METROPOLITAN GOVERNMENT OF NASHVILLE AND DAVIDSON COUNTY

STAFF RECOMMENDATION
312 Broadway
October 15, 2014

Application: Rehabilitation – storefront and windows; New construction – addition
District: Broadway Historic Preservation Zoning Overlay
Council District: 19
Map and Parcel Number: 09306400500
Applicant: Bill Johnson, Architect
Project Lead: Sean Alexander, sean.alexander@nashville.gov

Figure 1: 312 Broadway

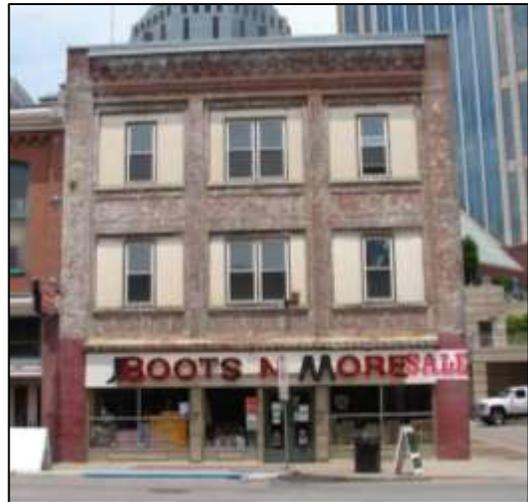
The historic storefront appears to be largely intact, but the original bulkheads, columns and other components have been covered with wood panels to give the building a faux “western” look. Additionally, the second and third story windows have been replaced, but the original window openings are still apparent.

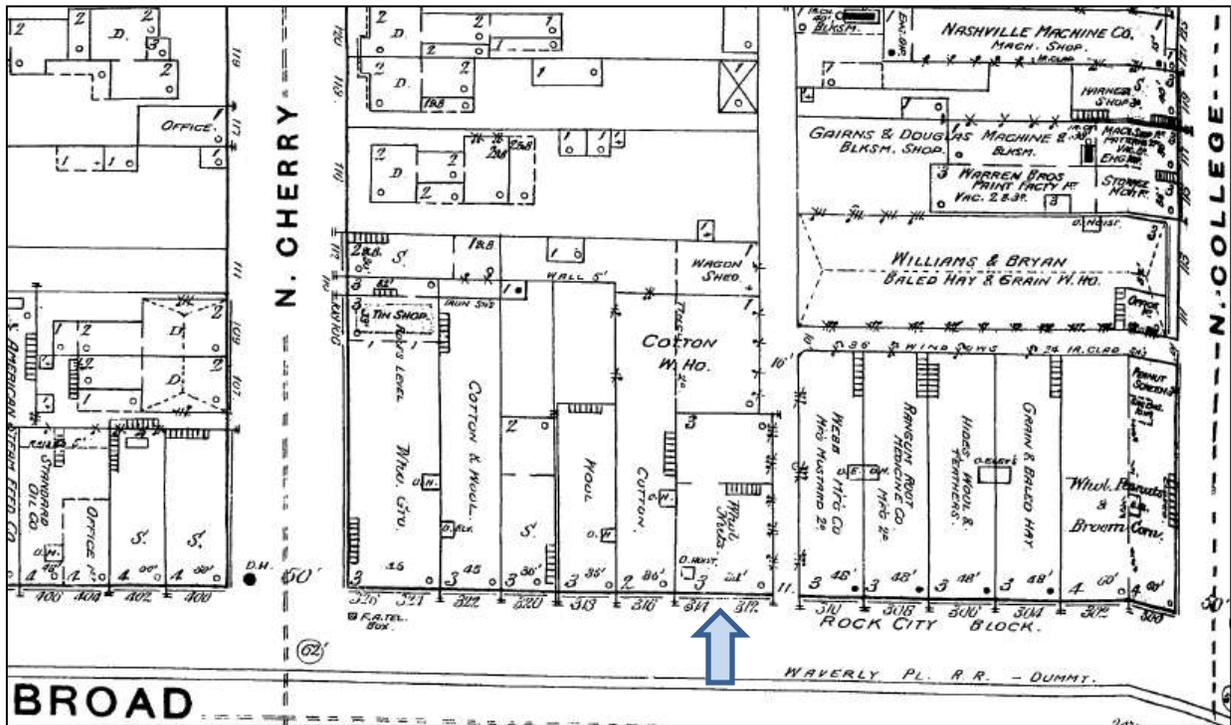
A new entrance with an aluminum storefront type door is proposed to be added on the right side of the building, with a new metal canopy matching the canopy proposed to be above the storefront. This location is appropriate because the right elevation faces an alley. Additionally, the materials are appropriate and will match those of the storefront.
